**Technische Mitteilung / technical information (service bulletin)**

**Nummer / No. FK14 # 02-2009**

Muster/model: FK 14  
Baureihe/ type: B + B2 serial number # 035 - 096  
Betreff/subject: Einbau der Kraftstofffilter / installation (position) fuel filter  
gültig ab/valid from: sofort/ with immediate effect  
gültig für/valid for: Produktion/manufacture Wartung/maintenance

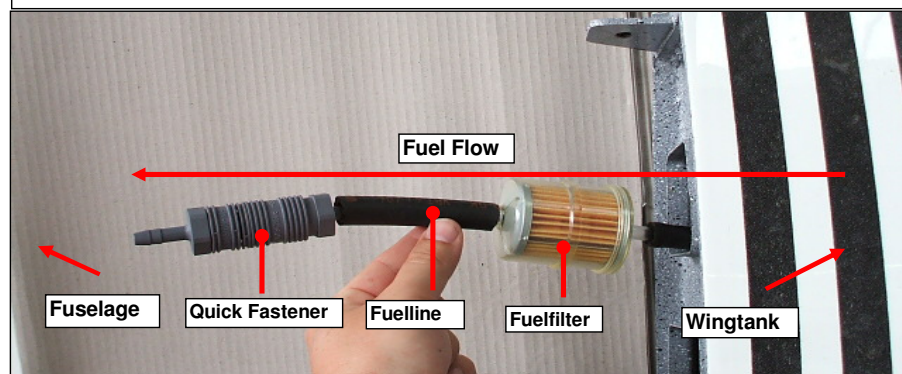
Beschreibung/description: Unterbrechung der Benzinversorgung durch verschmutzte Schnellverschlüsse / Interruption of fuel flow by conterminated quick fasteners

**Falls ein Kraftstoff Schnellverschluss montiert ist, muss in Flussrichtung gesehen zuerst der Benzinfilter und dann der Schnellverschluss montiert werden. Dadurch werden Schmutzpartikel und Fremdstoffe im Filter zurückgehalten und können den Schnellverschluss nicht verstopfen. Diese Überprüfung / Änderung ist an beiden Flächen durchzuführen!**

**If a fuel quick fastener is mounted, in fuel flow direction seen first the fuel filter and then the quick fastener must be mounted. Dirty particle and foreign matters are thereby held back in the filter and cannot block the quick fastener. This inspection / modification is to be carried out in both wings!**
